Product Change Notice (PCN)

PCN Number: **PCN-0454905R-01**

Product(s) Affected: **PJ-079BH**

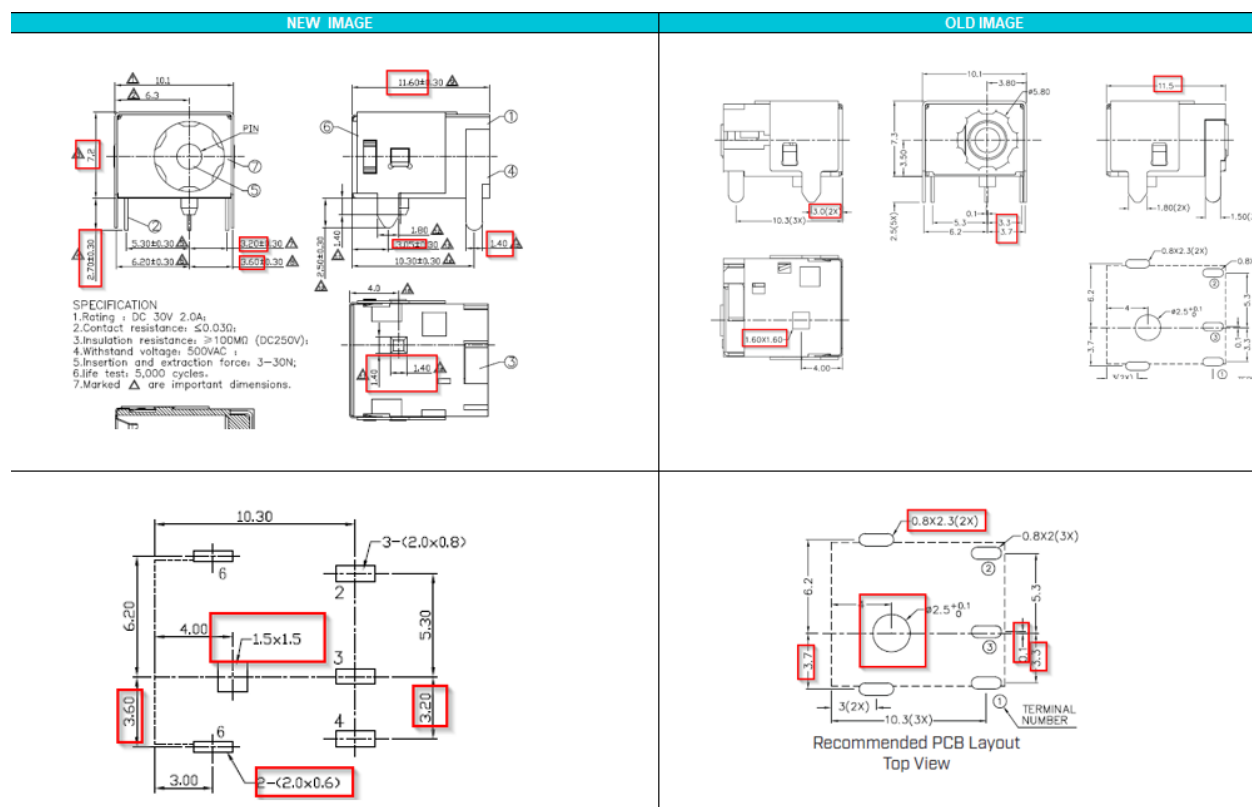
Description of Change: **Minor Housing and footprint differences. Material Change on the housing and terminals. See image Below**

Housing and Terminal Material Changes:

Center Pin: Copper to Brass
Terminal 2: Copper Alloy to Brass
Plastic: PA6T or Equivalent to PA9T
